SUBJECT: Addendum No. 2

South Lake Tahoe Court Interior ADA Upgrade Project

Contract No. PW 12-30657, Project No. 90108

SOUTH LAKE TAHOE COURT INTERIOR ADA UPGRADE PROJECT

RESTROOM PLAN

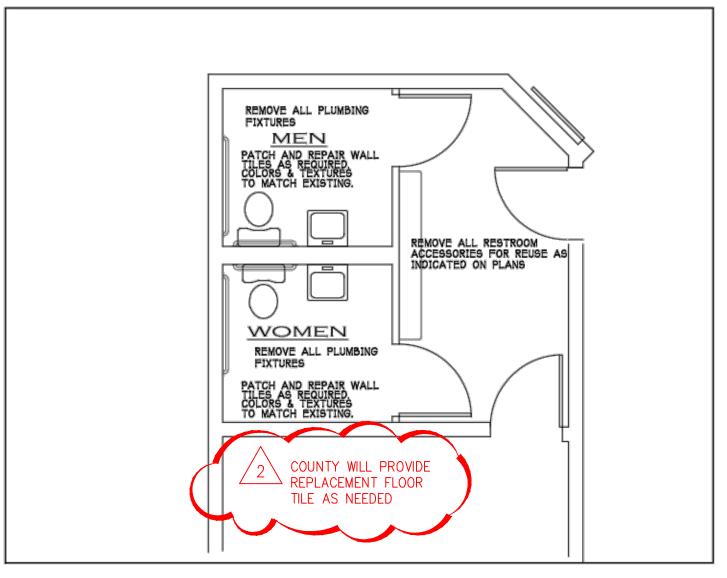
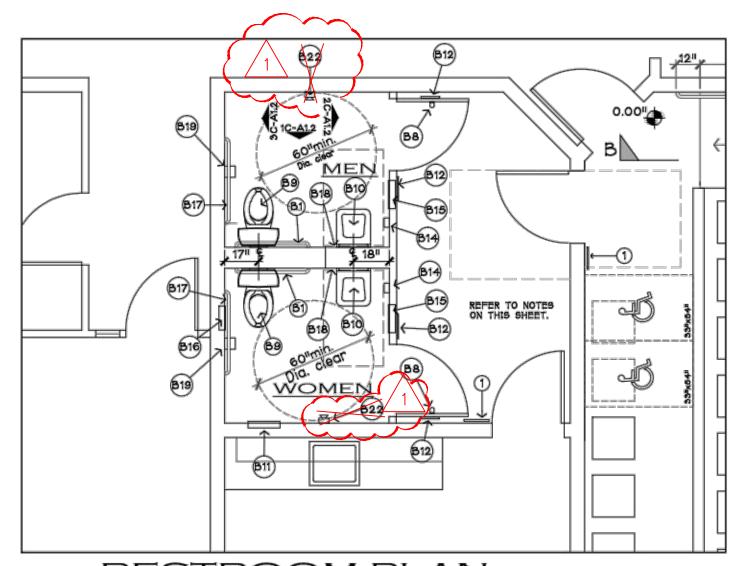
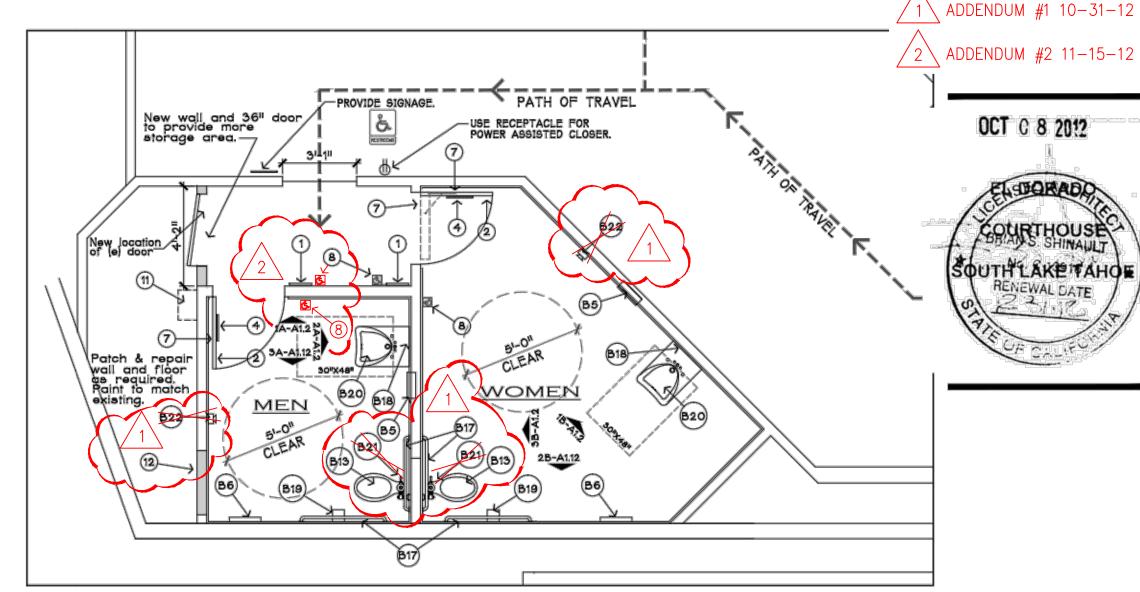
Answer: See revised plan sheet attached.
2.04	Plan Sheet: A1.2	Question: If it is confirmed that toilets in all 4 bathrooms of Department 3 and 4 need to be

moved over approximately 3" to conform with the 17" from wall called out in plans, will matching floor tile be supplied by county, or will entire tile floor need to be replaced with new tile? Question: Plan page A1.2 restroom plan for Department 12 does NOT show a location for RF switches at men's restrooms. Please advise if these are to be included.
2.05	Plan Sheet A1.3	Answer: See revised plan sheet attached. Question: Is there a carpet patch required where
		the public counter is lowered in the Clerk's Office?
		Answer: See revised plan sheet attached.
2.06	Cover Sheets and Notice	All references to the bid opening on Friday,
	to Bidders	November 16, 2012 at 2:00 PM shall be revised to:
		Tuesday, November 20, 2012 at 2:00 PM
